In response to committee member feedback, several key design moves have occurred which aim to enhance how the building form meets the Ground. These key moves look to improve the amenity space offering for building occupants, increase the public realm, and increase engagement of the building with the public realm. Simultaneously, these design moves look to add 'clarity of design form' to improve users' and passersby' overall understanding of the proposal. The following sketches articulate these key design moves.

Landscape - Supplementary tree & shrub planting

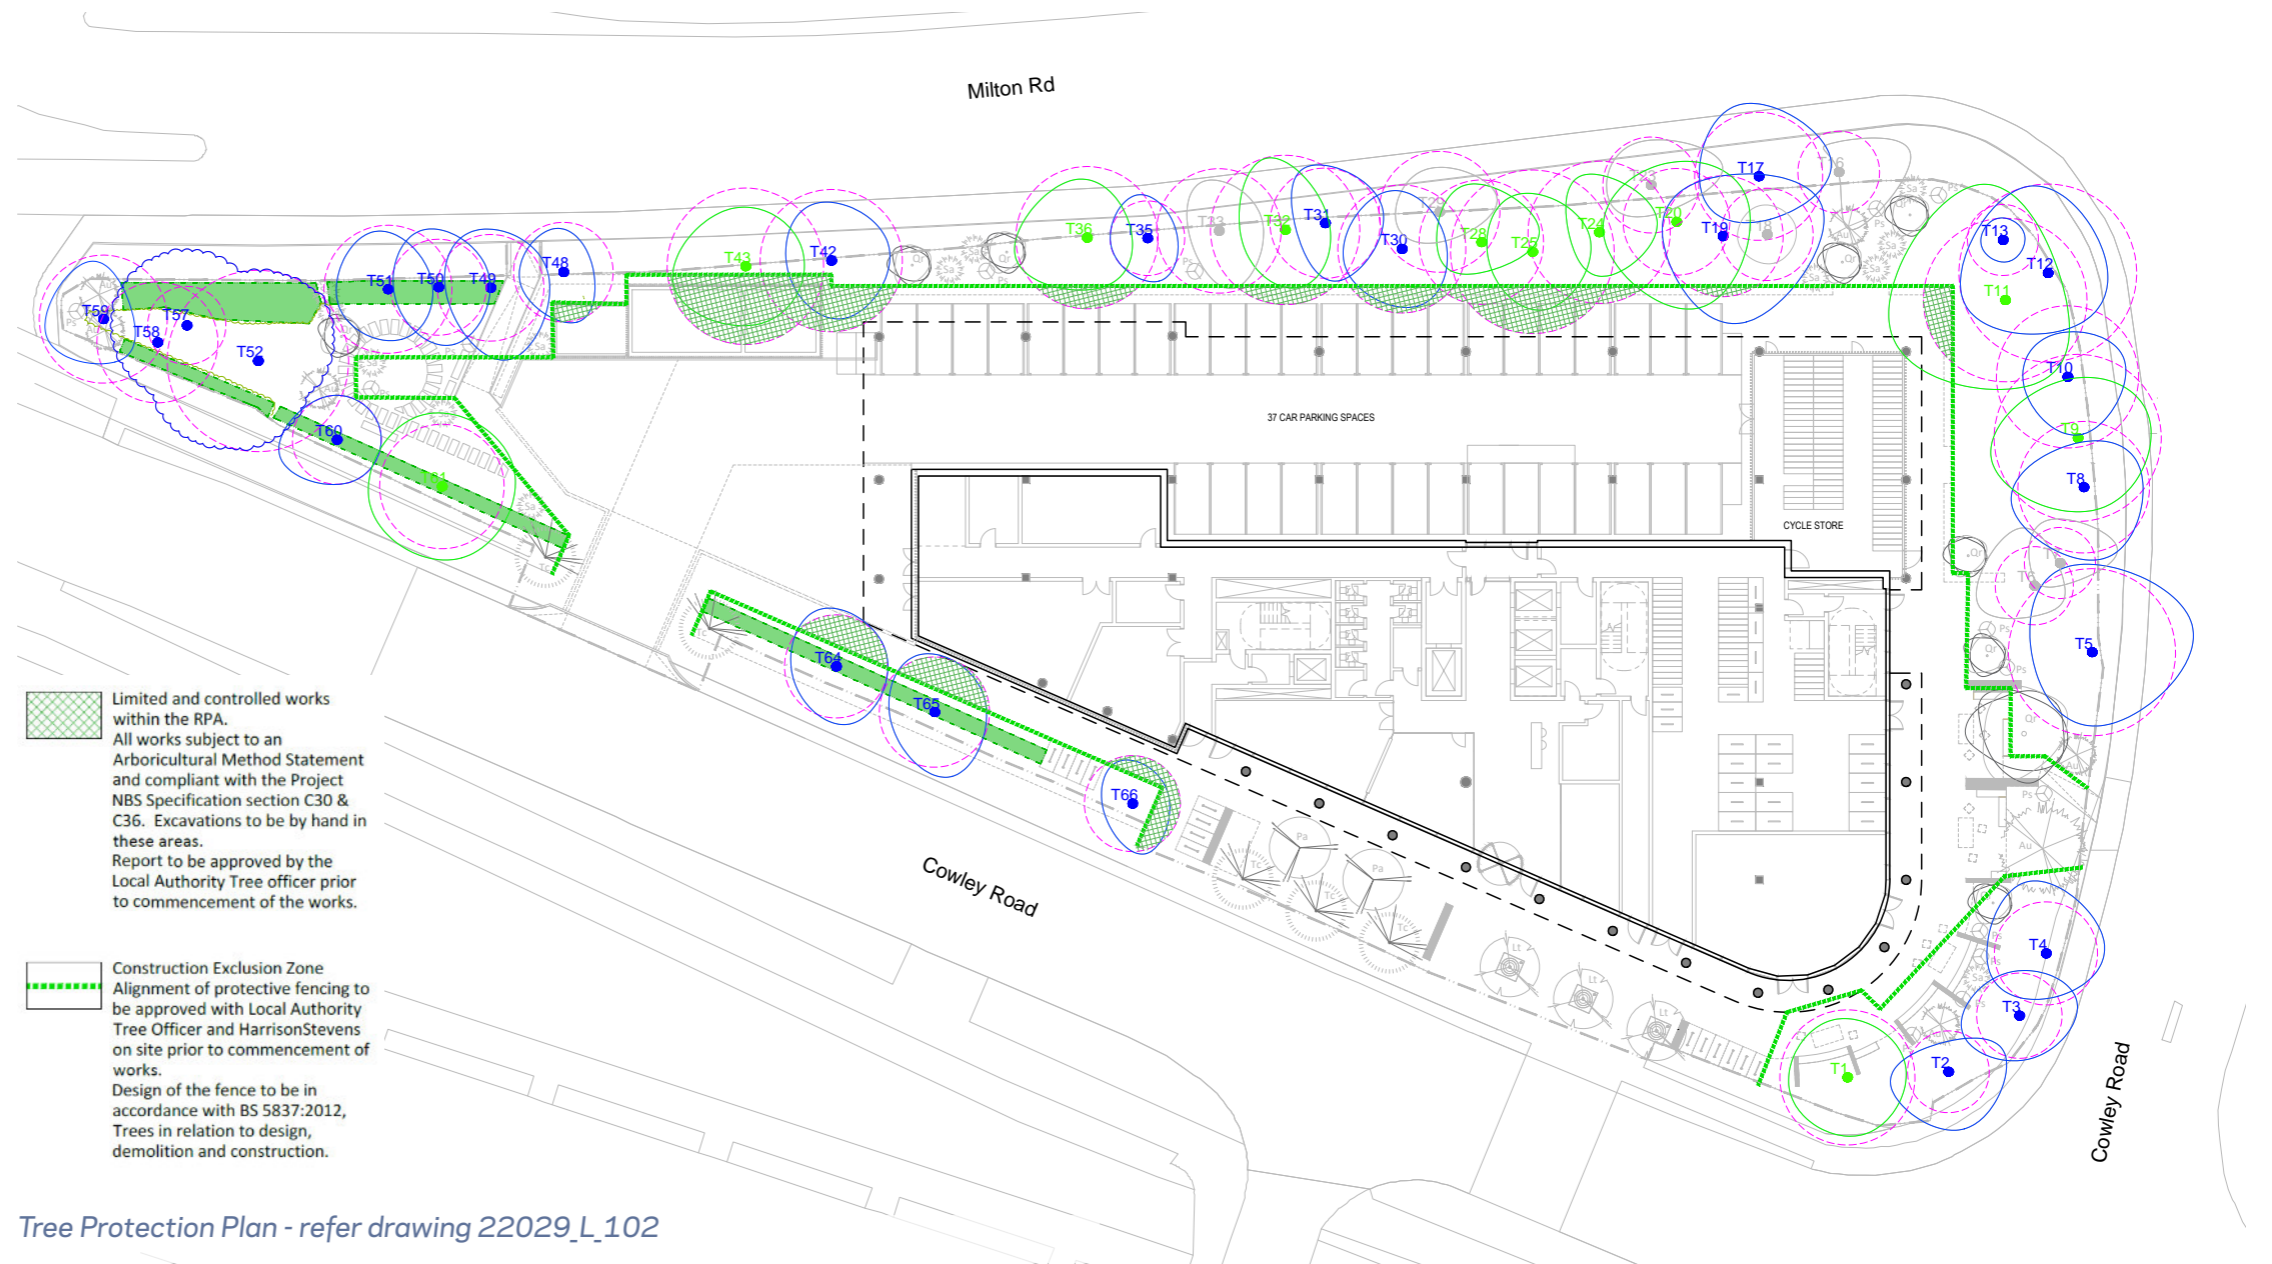
Provide some commentary on tree removal and new landscaping

- 74 total existing trees on site
- 24 of the existing trees are proposed for removal
- 53 new trees are to be planted
- A net gain of +29 trees on site
- An increase of +8 additional existing trees retained from previous planning submission
- Entrance plaza and cafe has additional tree planting from previous submission.

Landscape - Cafe corner

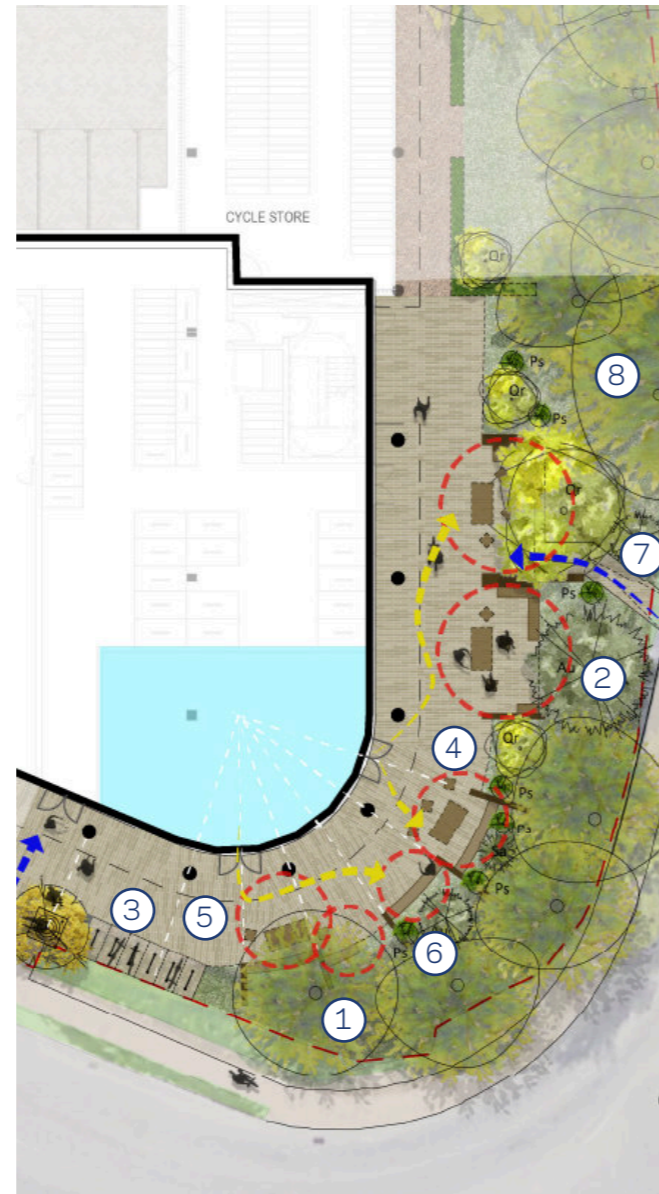
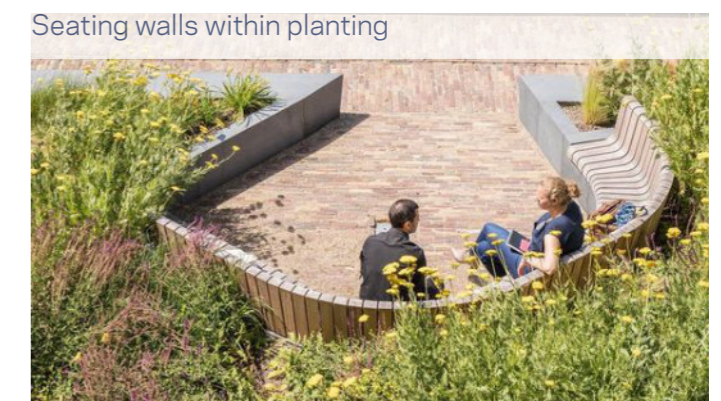
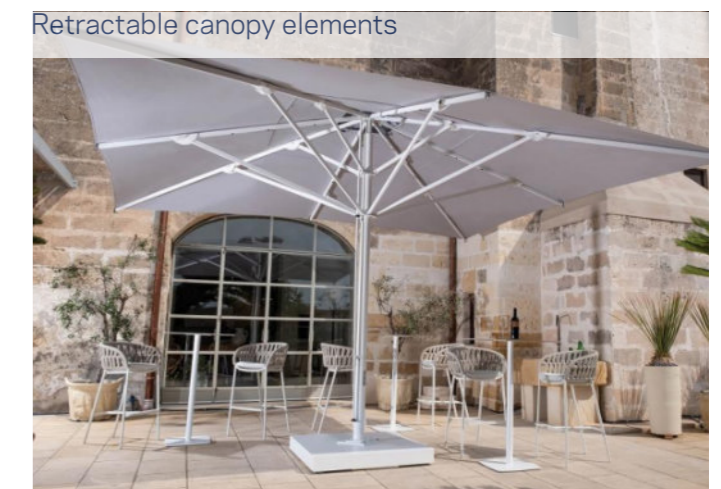
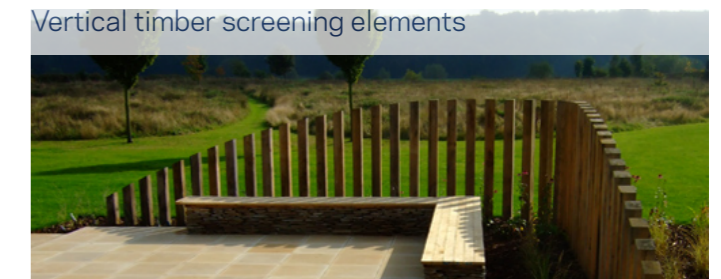
Provide some commentary on tree removal and new landscaping

Is the seating space location optimal to encourage dwell time?

Consider partial screening

Review overall ambience of external space

Can we make the outdoor space more appealing in cold weather?

Concern over steps in landscape

- Inter-planted shrub and ground cover planting underneath existing tree canopies
- Timber screening elements will be incorporated for seclusion and screening from Milton Road elements
- Cover over external seating will be with temporary / move-able canopies
- Extension of external cafe space, greater accessibility and movement around area

SOLAR EXPOSURE WITH OVERHANGING ROOF/SHADING ADDED

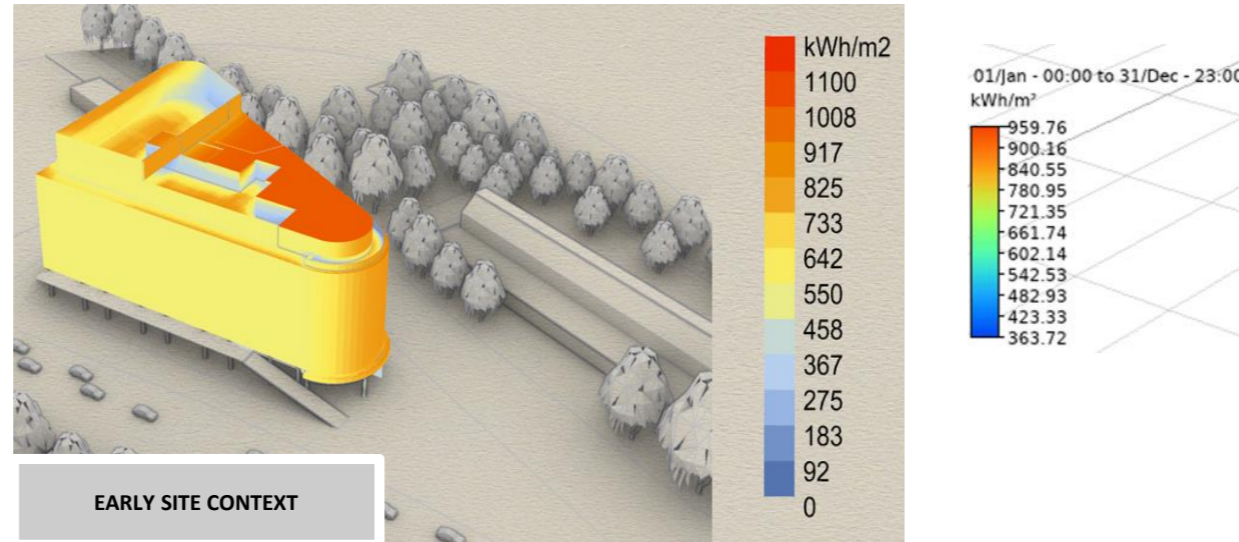
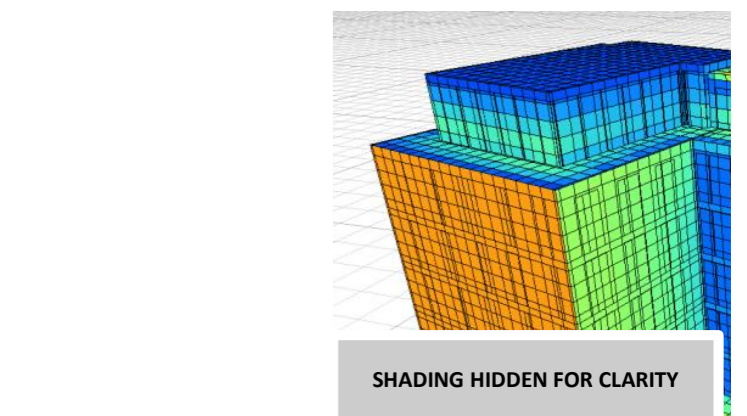
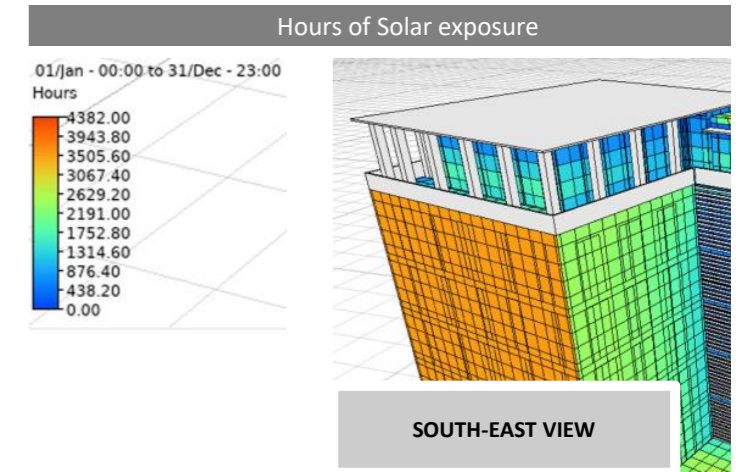
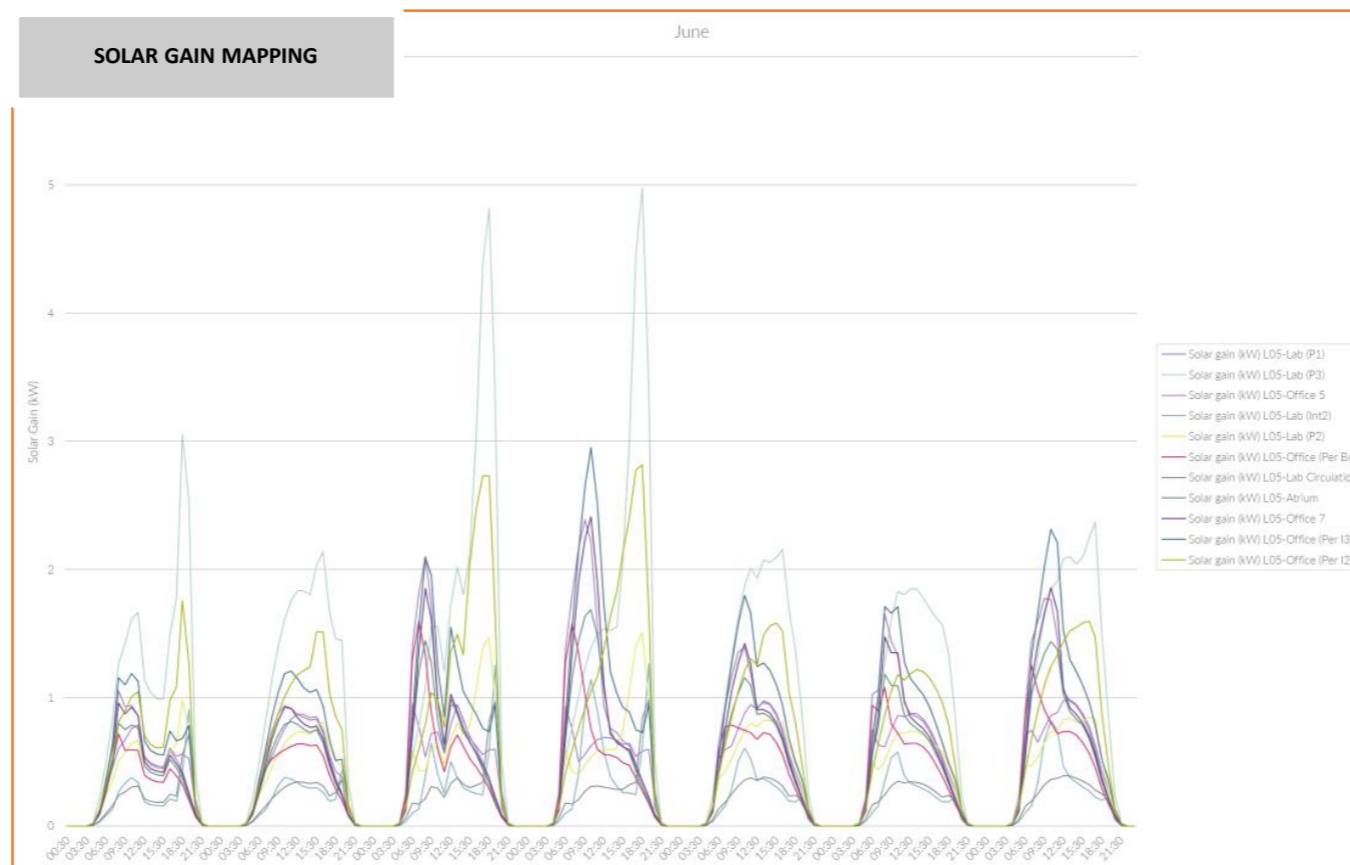
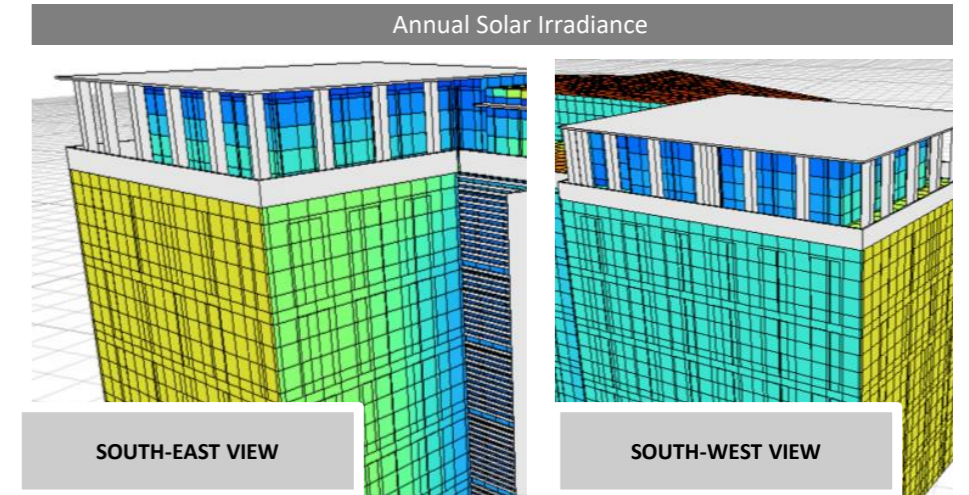
Lantern glazing / potential overheating to be clarified

During Stage 2, solar irradiance mapping and detailed solar gain analysis was completed.

In response to this modelling, the overhanging roof of the 'lantern' was developed to provide passive solar shading.

As demonstrated in the adjacent images, the lantern overhang provides significant shading to the top floor

During Stage 3, dynamic thermal modelling will be completed to refine the glazing detail of the lantern feature in line with the overheating hierarchy including Glazing spec and G-value, the introduction of opaque elements, and further opportunities for external shading.

After the implementation of passive reduction measures, any required cooling to the space will be provided by high efficiency heat pump led plant.
